SEMINOLE COUNTY GOVERNMENT
1101 EAST FIRST STREET, 2ND FLOOR, WEST WING
SANFORD, FLORIDA 32771

PROJECT NAME:	LAKE SHORE DR - PRE-APPLICATION	PROJ #: 24-80000022
APPLICATION FOR:	DR - PRE-APPLICATION DRC	
APPLICATION DATE:	2/27/24	
RELATED NAMES:	EP BRENDA PEARCE	
PROJECT MANAGER:	KATHY HAMMEL (407) 665-7389	
PARCEL ID NO.:	24-21-29-508-0H00-011A	
PROJECT DESCRIPTION	PROPOSED SPECIAL EXCEPTION FOR A NEW WATER METER SYSTEM ON 0.24 ACRES IN THE R-1AA ZONING DISTRICT LOCATED ON THE WEST SIDE OF LAKE SHORE DR, SOUTH OF ORANOLE RD	
NO OF ACRES	0.24	
BCC DISTRICT	3-LEE CONSTANTINE	
CURRENT ZONING	R-1AA	
LOCATION	ON THE WEST SIDE OF LAKE SHORE DR, SOUTH OF ORANOL E RD	
FUTURE LAND USE-	LDR	
APPLICANT:	CONSULTANT:	
BRENDA PEARCE BLACK & VEATCH/SUNSHINE WATER 200 WEATHERSFIELD AVE ALTAMONTE SPRINGS FL 32714 (678) 656-5179 PEARCEB@BV.COM	N/A

PROJECT AREA ZONING AND AERIAL MAPS

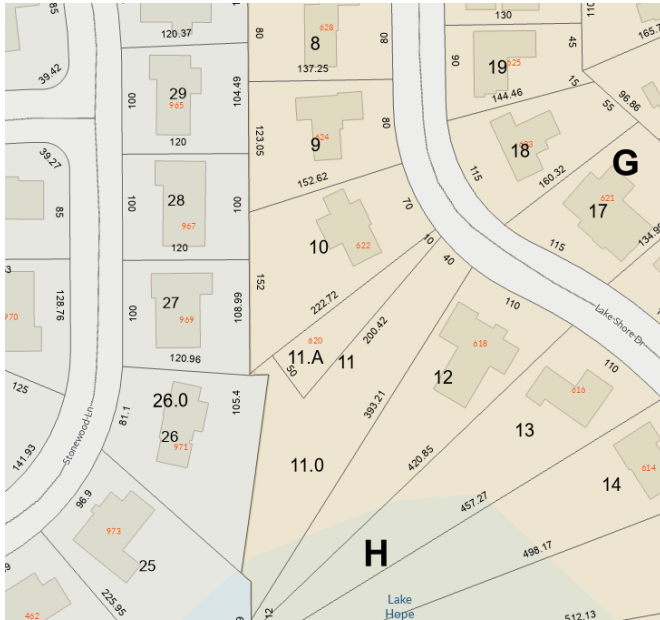
The parcel located within unincorporated Seminole County have a zoning classification of R-1AA (Single Family Residential).

The installation of a pole with an antenna for a new water metering system will require a Special Exception to allow the use in the applicable zoning district. A variance to the building/structure height of 35 feet may also be required.
